City of Santa Barbara California

PLANNING COMMISSION STAFF REPORT

REPORT DATE: July 3, 2013
AGENDA DATE: July 11, 2013
PROJECT ADDRESS: South Coast 101 HOV Lanes Project Update
TO: Planning Commission
FROM: Planning Division, (805) 564-5470, extension 4550
 Renee Brooke, AICP, Senior Planner *RLB*
 Daniel Gullett, Associate Planner *DPG*
 Rob Dayton, Principal Transportation Planner *DPG*

Figure 2-12 Conceptual Image of Interchange Configuration F Modified

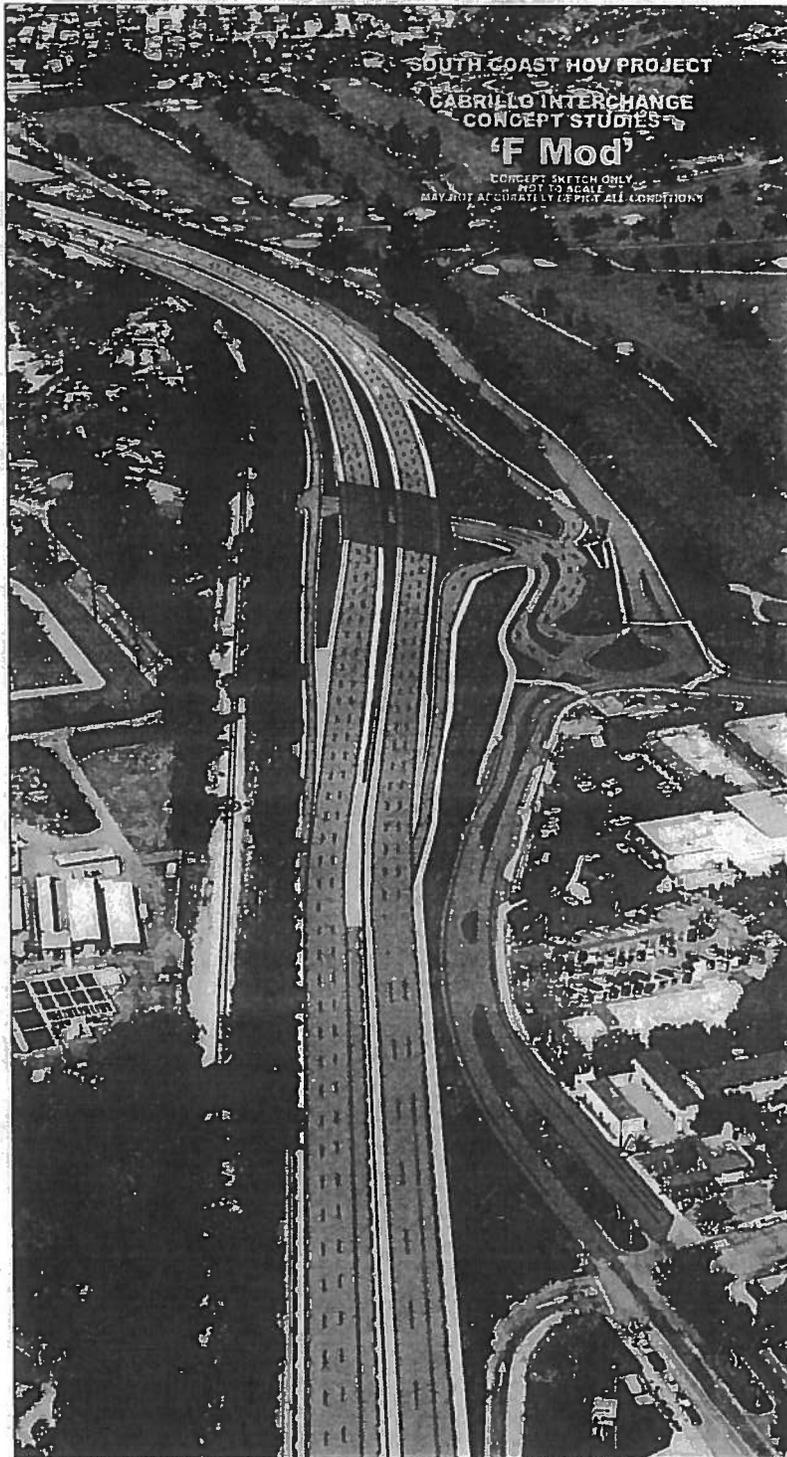
- 25) Page 183-185 – Visual Simulation OV-21 - Configuration F, F Mod, J, and M
- Why do these configurations result in the loss of so many large skyline trees? Figures 2-11 through 2-15 do not show this, and there is no description of the reason for the loss in the previous text.

- 32) Page 195 – Visual Simulation OV24A - Configuration F
- a) The loss of skyline trees still has not been adequately described, and does not match with Figure 2-11 on page 177. According to Figure 2-11, the offramp would be built in the location of the existing SB mainline, which is being moved to the north, so removal of the skyline trees should not be necessary.

- 33) Page 196 – Visual Simulation OV24A - Configuration F Mod
- a) The loss of skyline trees still has not been adequately described, and does not match with Figure 2-11 on page 177. According to Figure 2-11, the offramp would be built in the location of the existing SB mainline, which is being moved to the north, so removal of the skyline trees should not be necessary.

FIGURE F

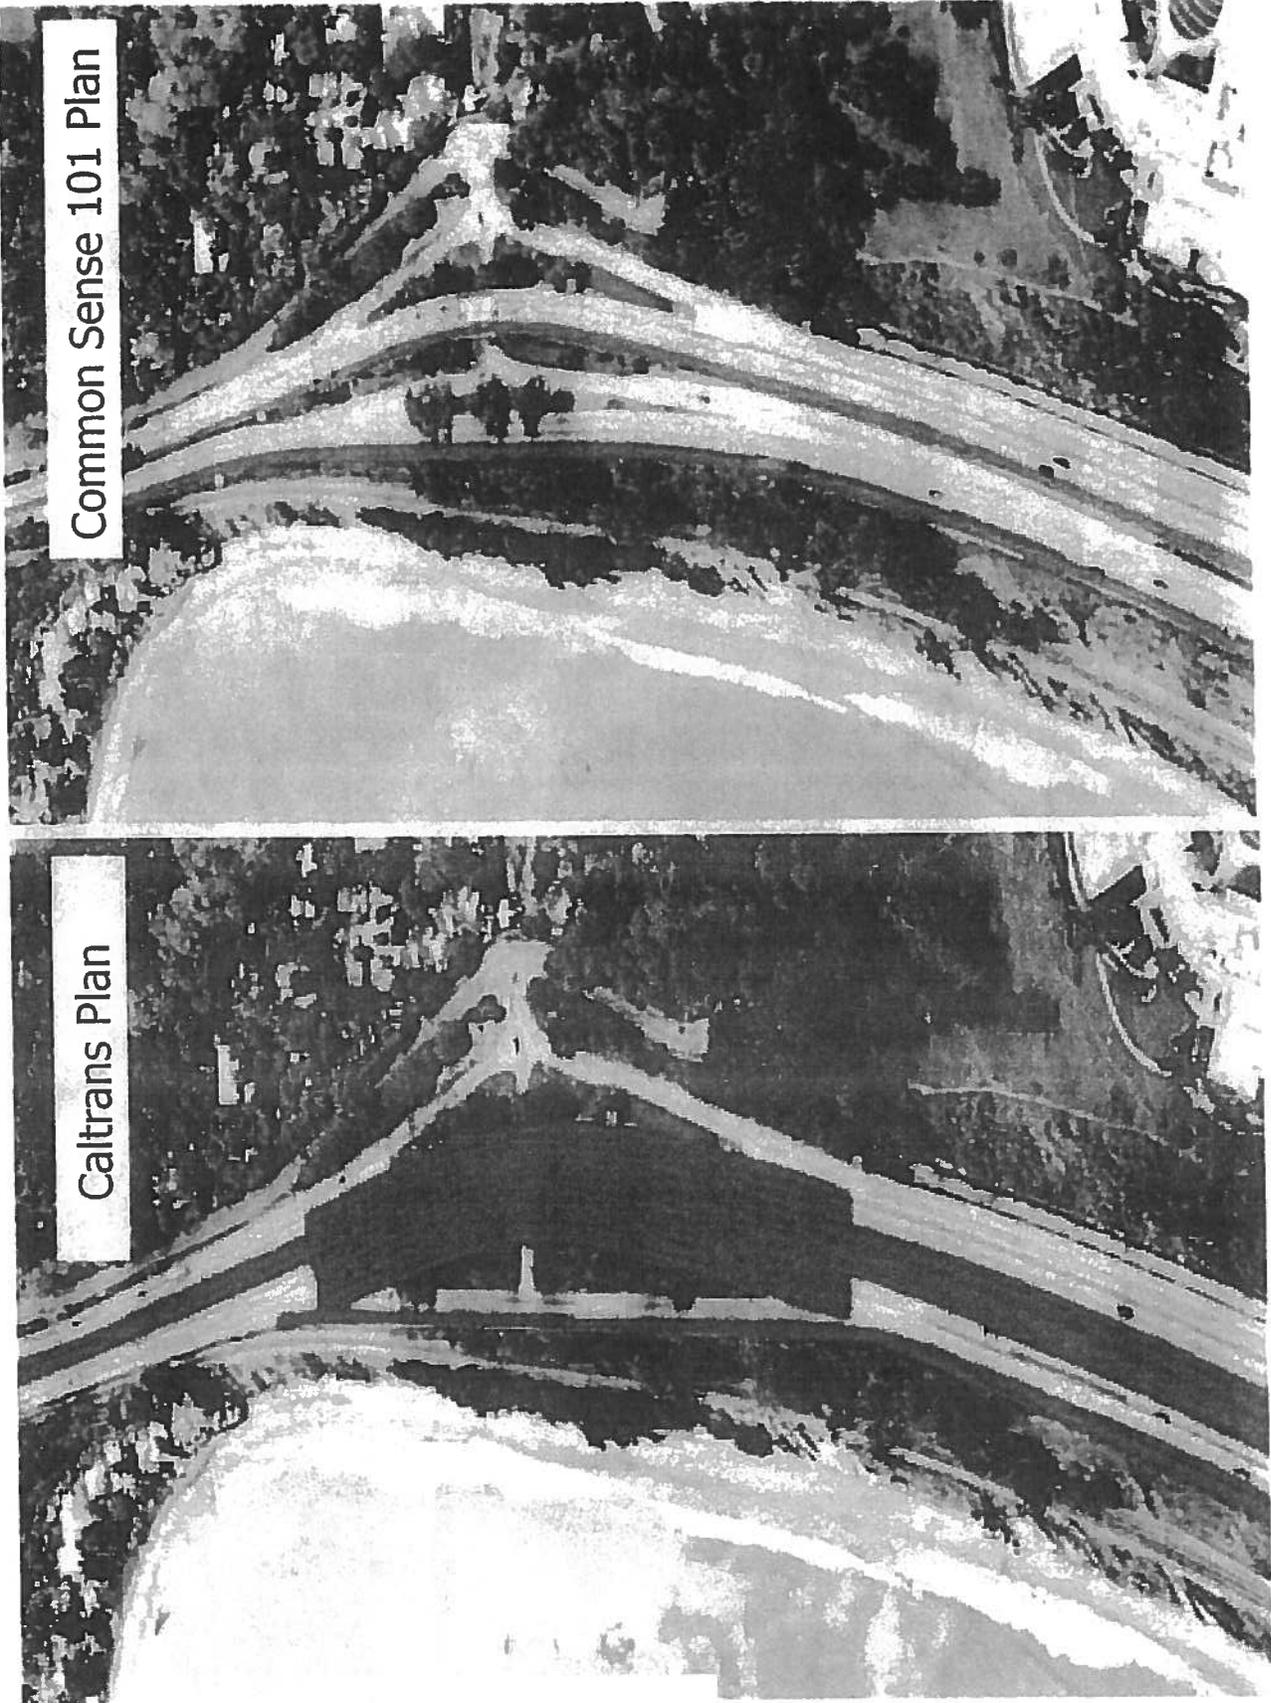
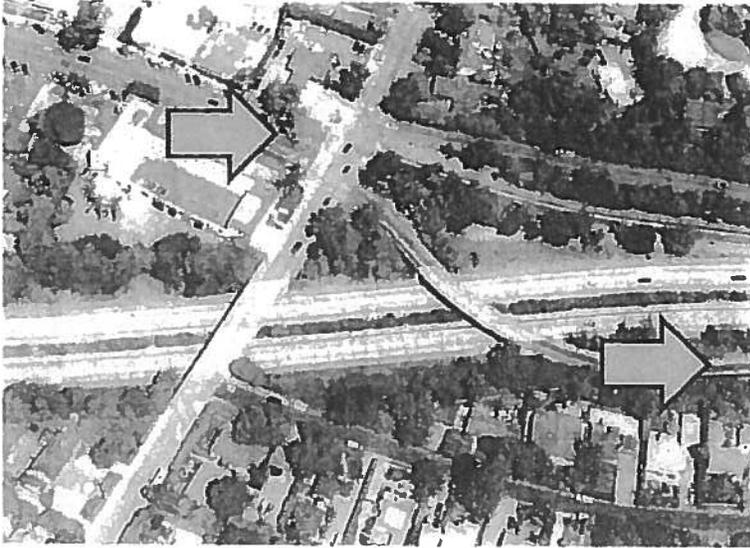
this roundabout.

The on-ramp, in the lower right-hand corner of the picture is short and enters on a curve too close to the off-ramp for San Ysidro that is also too short and backs up in the morning. Both conditions would be corrected by an auxiliary lane that connects the two ramps, and is included in the Common Sense 101 plan.
